2021 GROUP A PROPOSED CHANGES TO THE I-CODES

April 11 – May 5, 2021
Virtual Committee Action Hearings

2021 GROUP A – PROPOSED CHANGES TO THE INTERNATIONAL SWIMMING POOL AND SPA CODE

ISPSC: 322.4

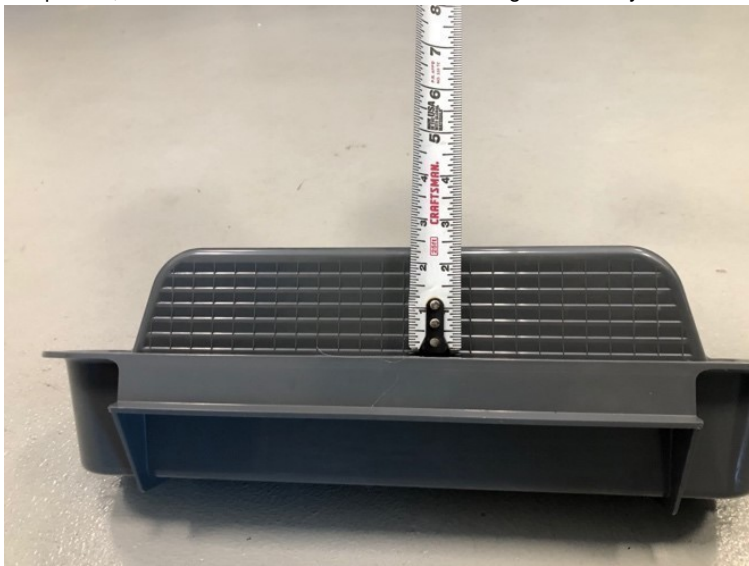
Cost Impact: The code change proposal will not increase or decrease the cost of construction. Most constructors of inground gunite pools have been using these recessed tread inserts for many years as they offer an easy and uniform method to create recessed treads in the wall of a pool. The difference in cost of the inserts versus the labor to hand form the tread without the insert is insignificant.
